SERVICE INFORMATION

Vol. 1 No. 8

LAND-ROVER PETROL AND DIESEL MODELS

October, 1972

Fig. 1 Fuel pump installation

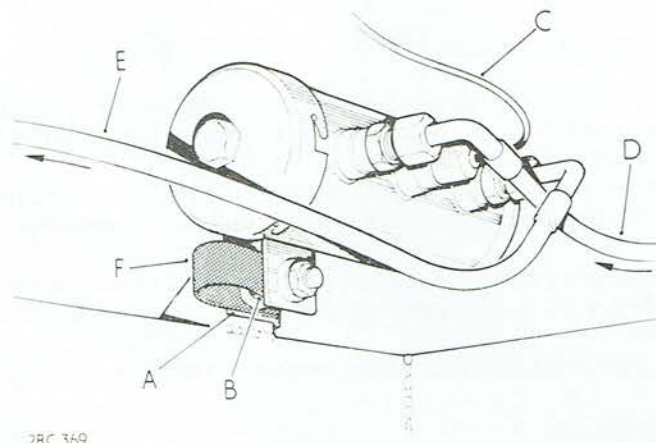
MODIFICATION: Introduction of Bendix electric fuel pump, replacing the S U fuel pump previously used, to overcome problems of corrosion.

The Bendix fuel pump is being fitted to current Land-Rover 109 vehicles with 2.6 litre engine.

Fig. 2 Removal tool for pinion head bearing

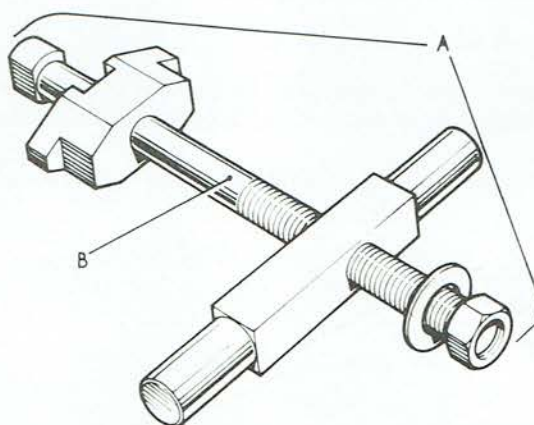
MODIFICATION: Introduction of a lengthened centre bolt for the differential pinion head bearing removal tool; the associated press block has also been modified to give improved contact with the head bearing. The centre bolt length has been increased from 180 mm (7 in.) to 230 mm (9 in.); press block diameter increased from 69 mm (2.7 in.) to 77 mm (3.0 in.).

On all Series III models and at the vehicle suffix letter change from 'G' to 'H' on Series IIA models, the pinion oil seal retainer is integral with the differential casing and not removable as previously; therefore a longer centre bolt has been provided for the Service tool used to remove and refit the pinion head bearing cup, to cater for the extra depth of casing involved.

Lengthening the centre bolt has resulted in a tool number change from 262757 (which remains suitable for early models) to 262757A which is suitable for both early and late models. The longer centre bolt is available separately under Part No. 262757A detail 3 to enable holders to modify their original tool Part No. 262757 which is then suitable for both early and late models.

Fig. 3 Press block for pinion head bearing

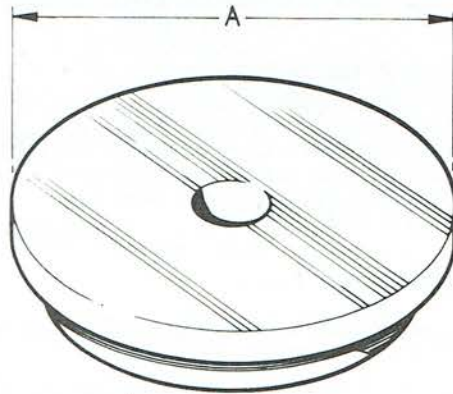
In conjunction with the above modification, the opportunity has been taken to provide a new press block which gives a greater contact area with the pinion bearing cup. The new press block Part No. 262757-1 replaces the earlier press block Part No. 262758 for the following models:

A—Early tool Part No. 262758 measures 69 mm (2.7 in.).
Later tool Part No. 262757-1 measures 77 mm (3.0 in.)

Fig. 4 Spanner for stub shaft nut

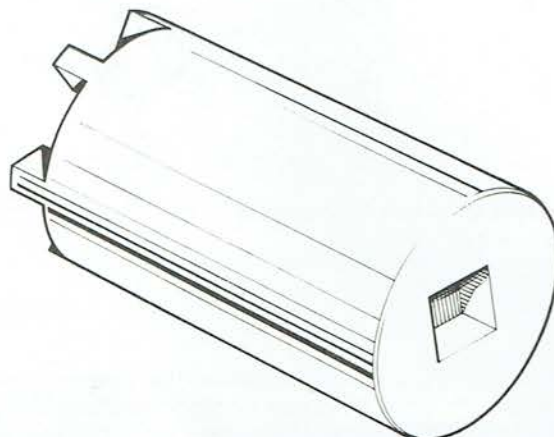
MODIFICATION: Introduction of a Service tool for removing/refitting the circular castle nut which retains the front hub driving member and the axle stub shaft.

REMARKS: The above Service tool is designed to engage in the castellations of the circular castle nut. The free end is provided with a 12.7 mm (0.500 in.) square hole to accept a suitable wrench.
